MASSACHUSETTS DEPARTMENT OF TRANSPORTATION HIGHWAY DIVISION

SPRINGFIELD MCKNIGHT COMMUNITY TRAIL			
STATE	FED. AID PROJ. NO.	SHEET NO.	TOTAL SHEETS
MA	-	1	66
PROJECT FILE NO.		608157

PLAN AND PROFILE OF MCKNIGHT COMMUNITY TRAIL

25% SUBMITTAL

CONSTRUCTION PLANS & PROFILES

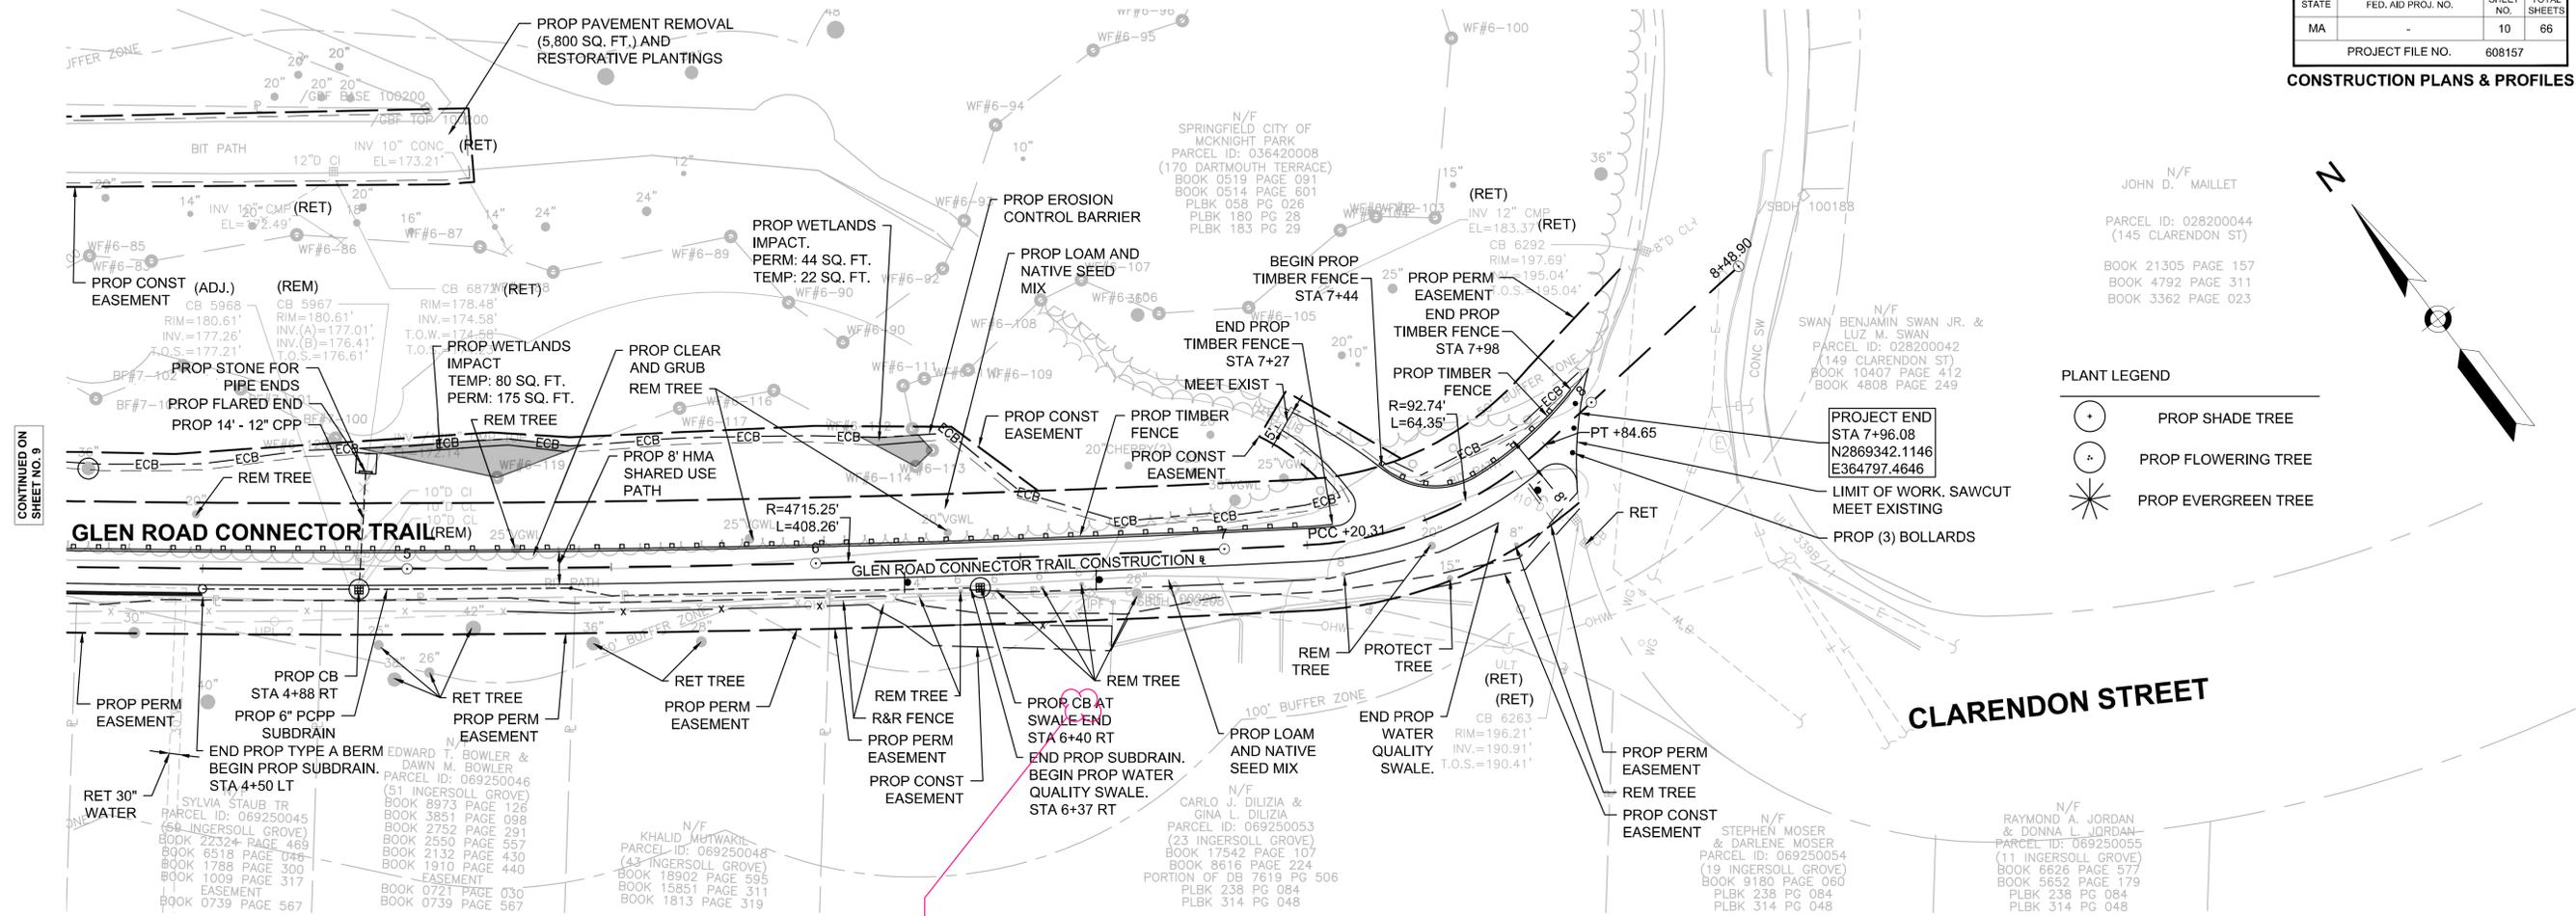
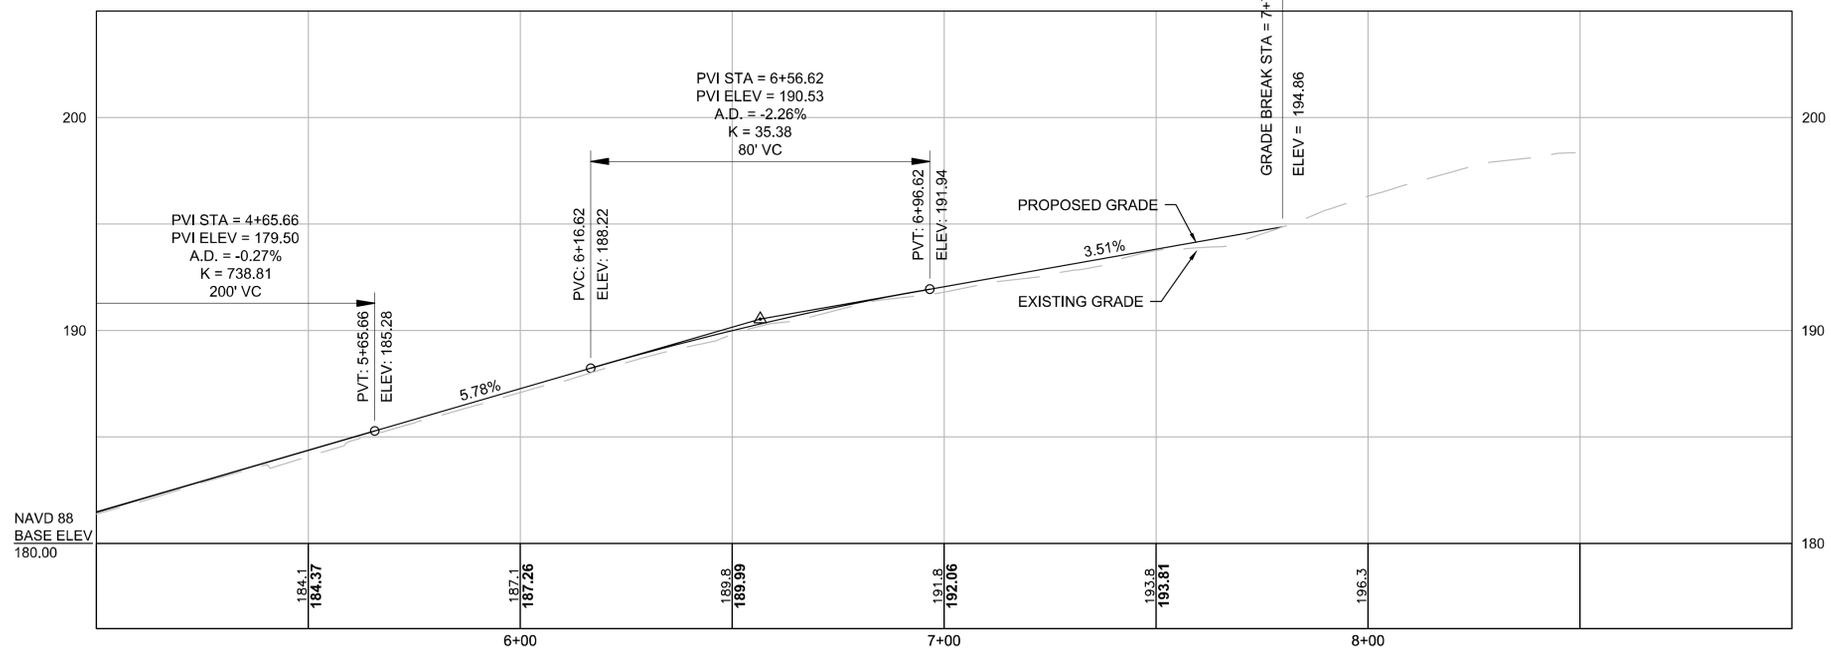
for drainage inlets in unpaved areas, drop inlets are recommended instead of catch basins because they have a throat to reduce clogging.

CONSTRUCTION PLANS & PROFILES

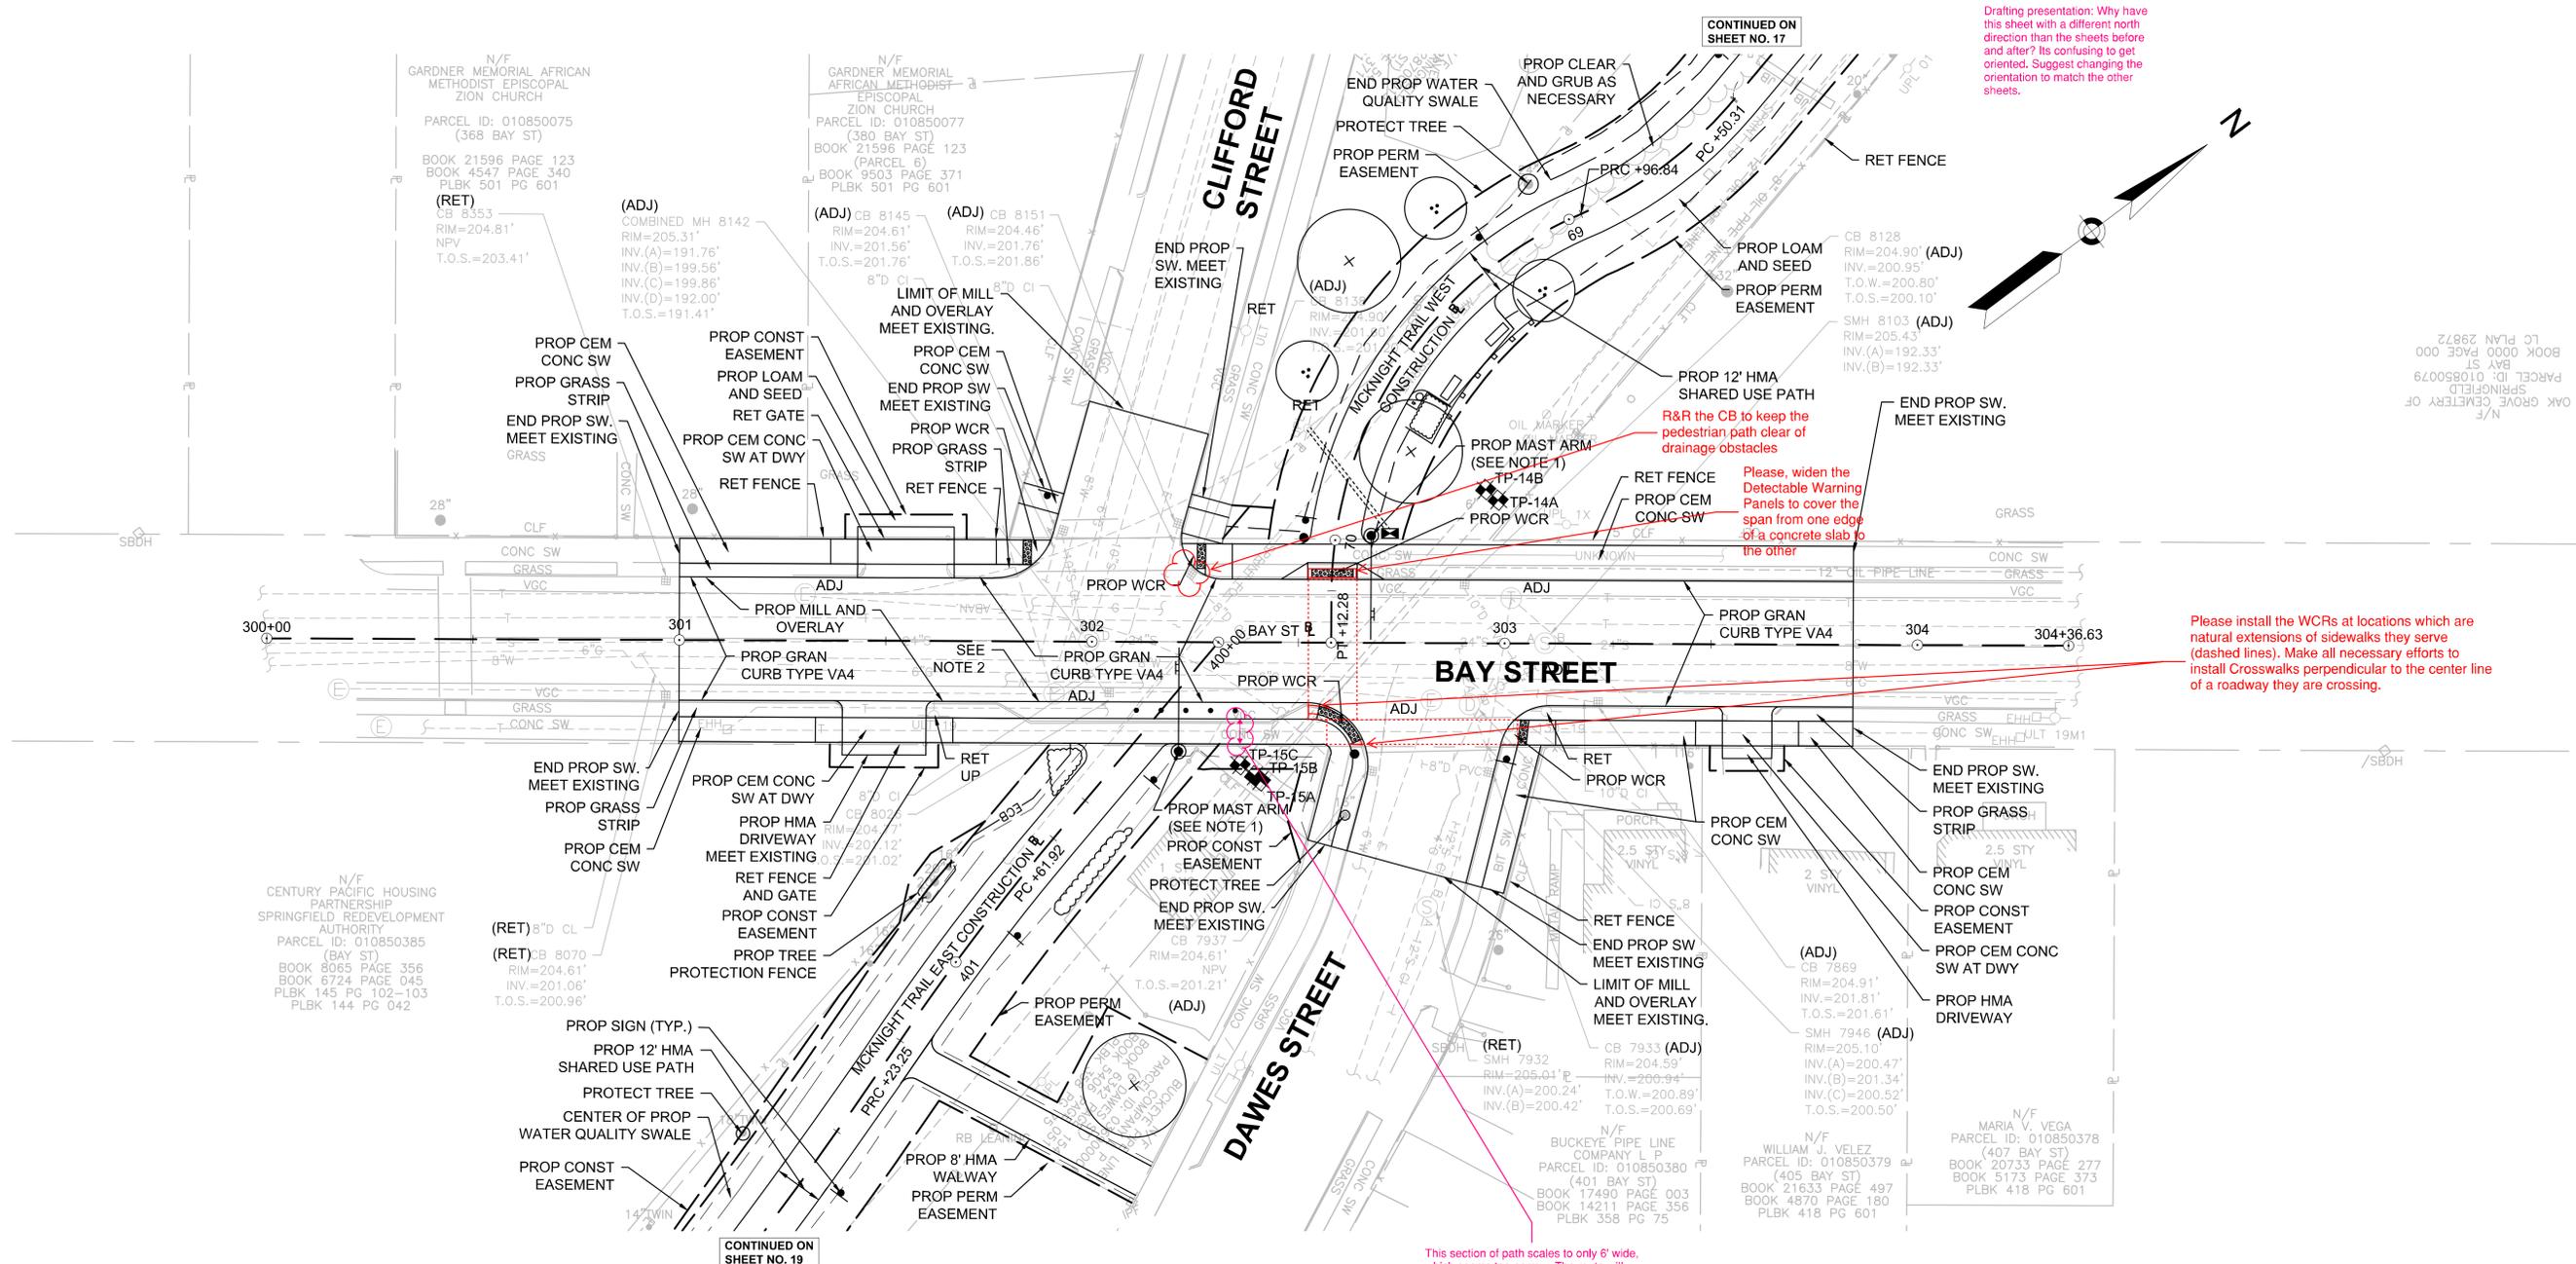
Drafting presentation: Why have this sheet with a different north direction than the sheets before and after? Its confusing to get oriented. Suggest changing the orientation to match the other sheets.

CONSTRUCTION PLANS & PROFILES

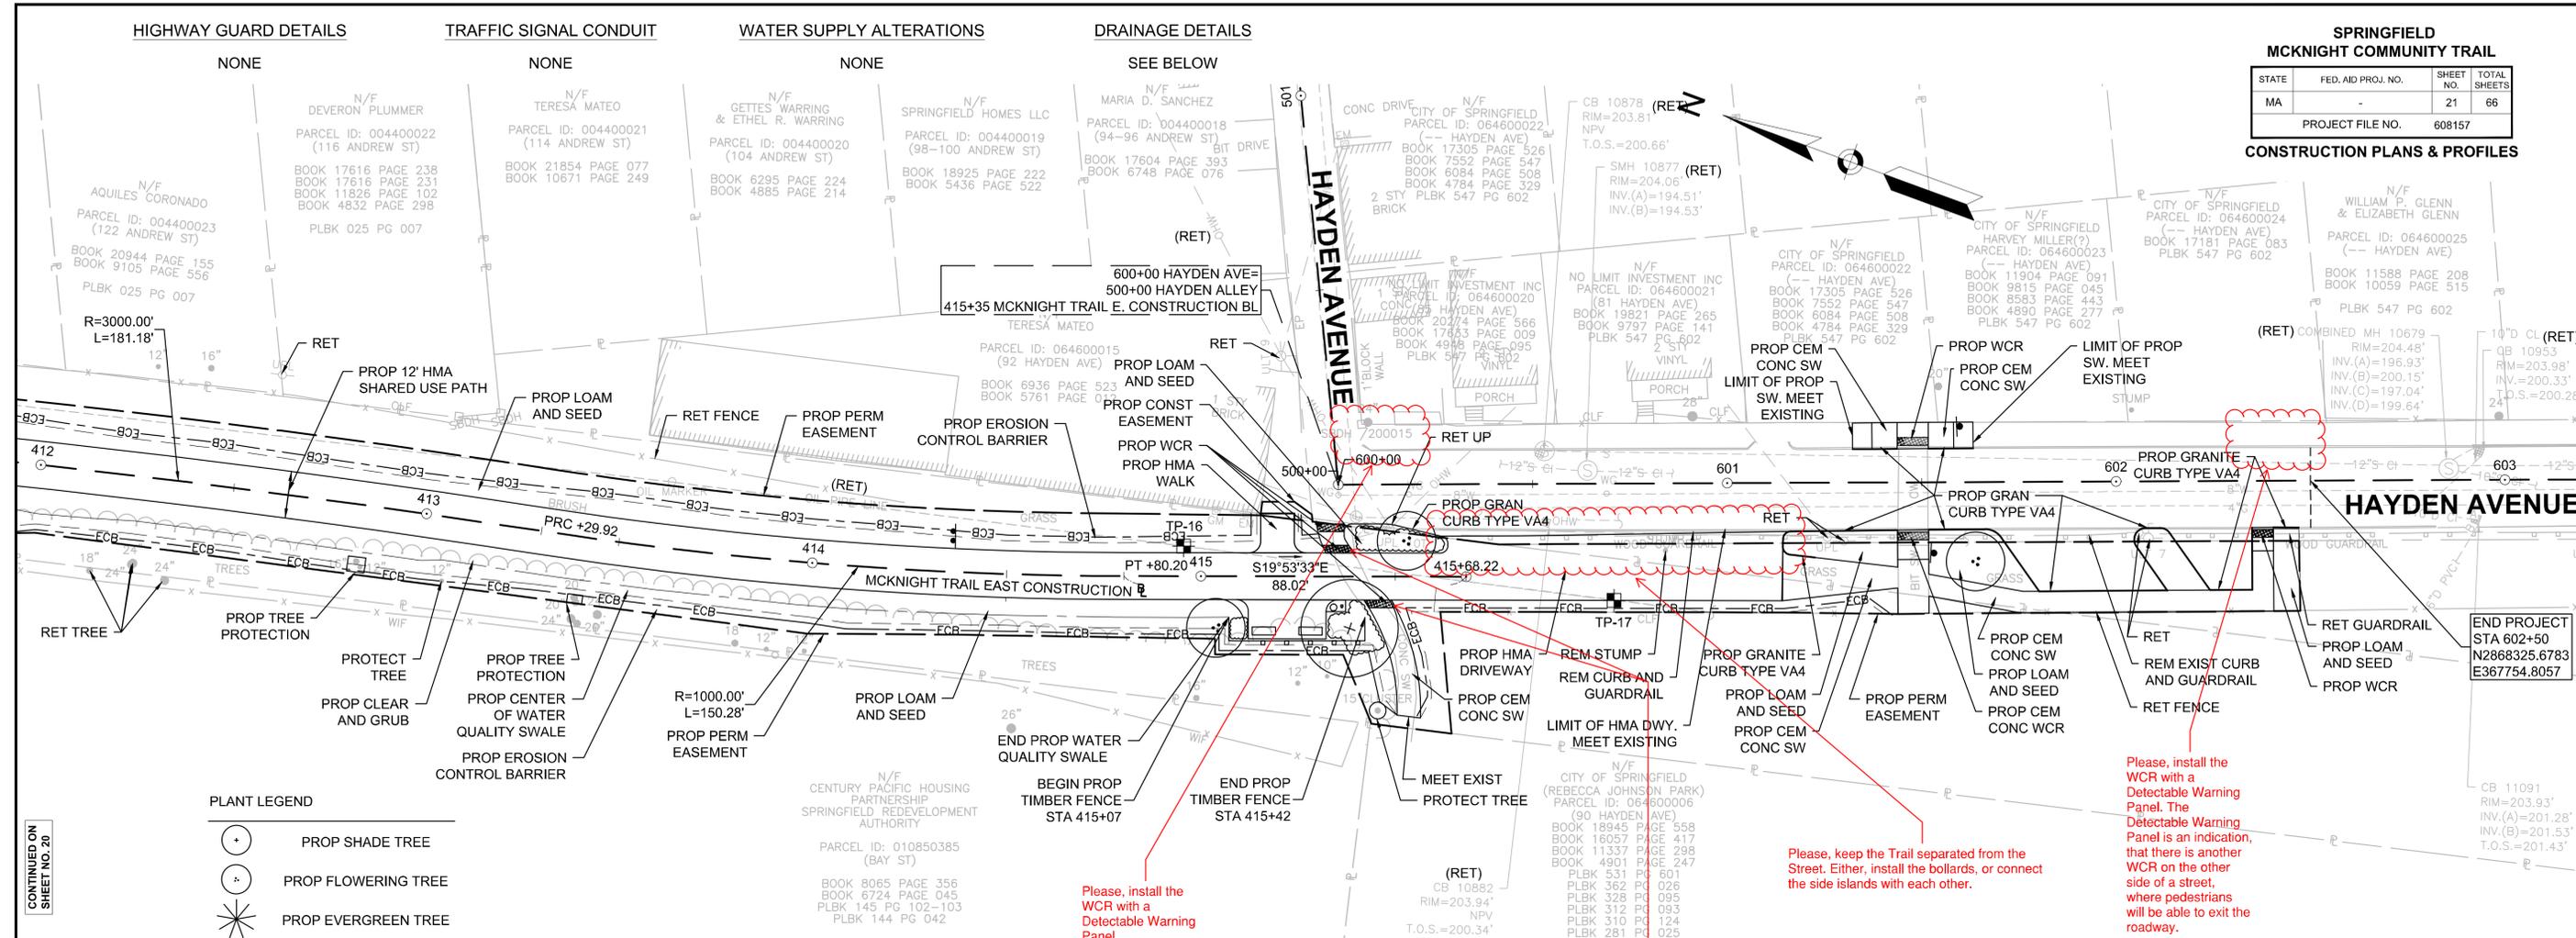
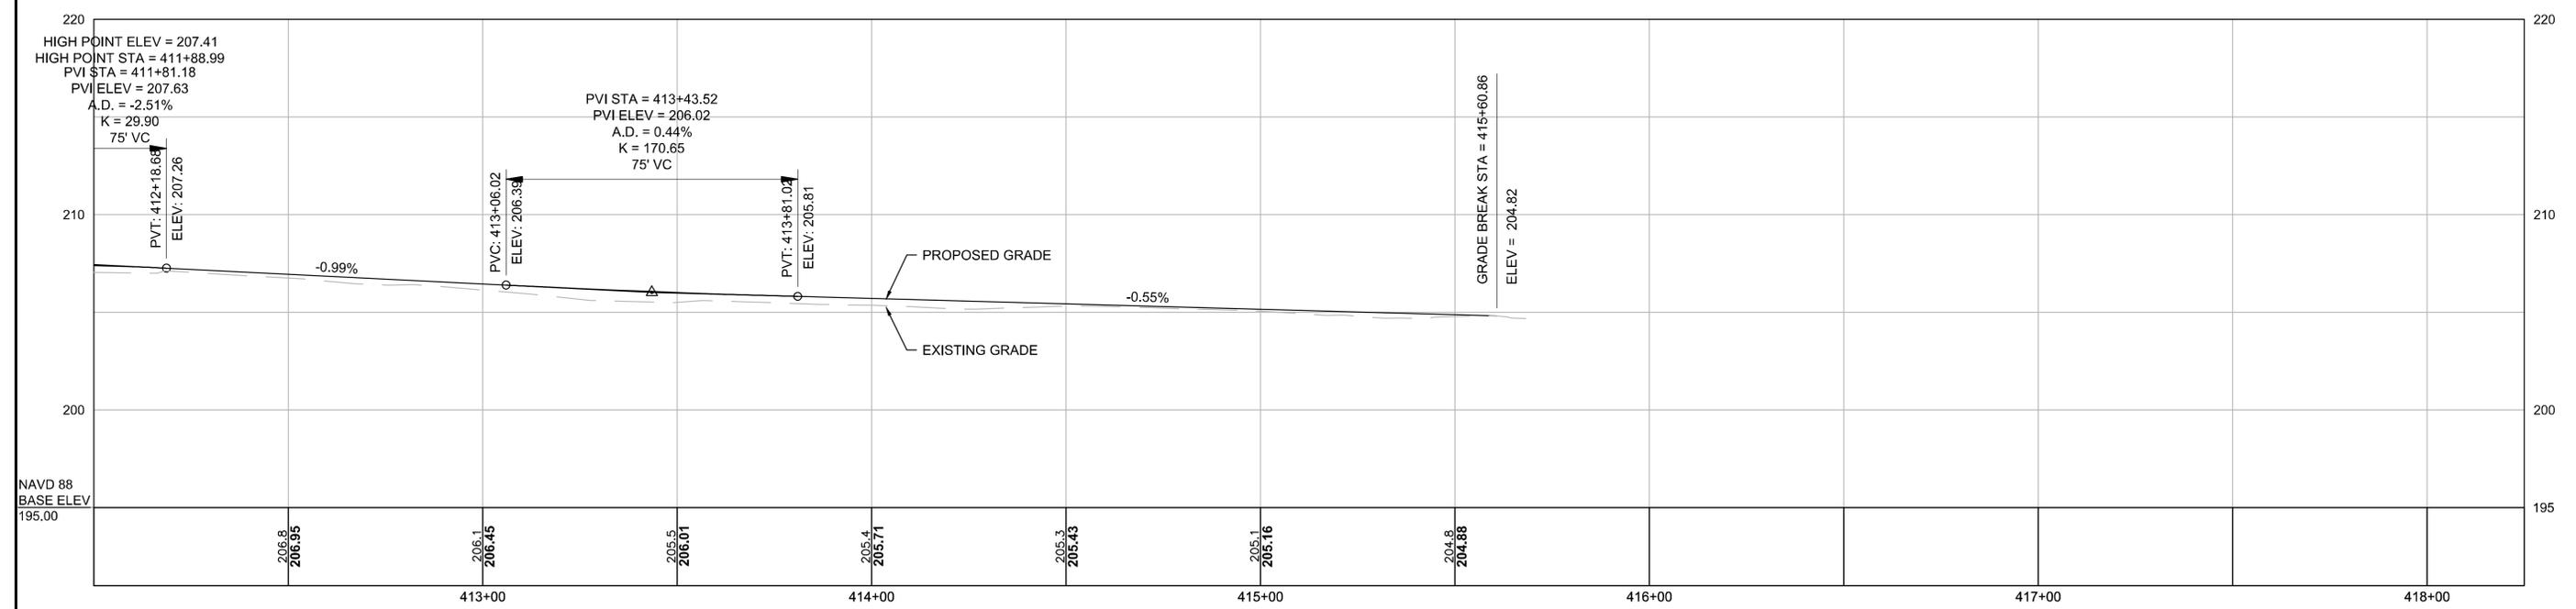
Please, install the WCR with a Detectable Warning Panel.

Please, keep the Trail separated from the Street. Either, install the bollards, or connect the side islands with each other.

Please, install the WCR with a Detectable Warning Panel. The Detectable Warning Panel is an indication, that there is another WCR on the other side of a street, where pedestrians will be able to exit the roadway.

These two Detectable Warning Panels are unnecessary. The sidewalks are connecting to the Shared Path, which is intended for use by pedestrians and bicyclists, only. The motor vehicles are prohibited on the Shared Path.
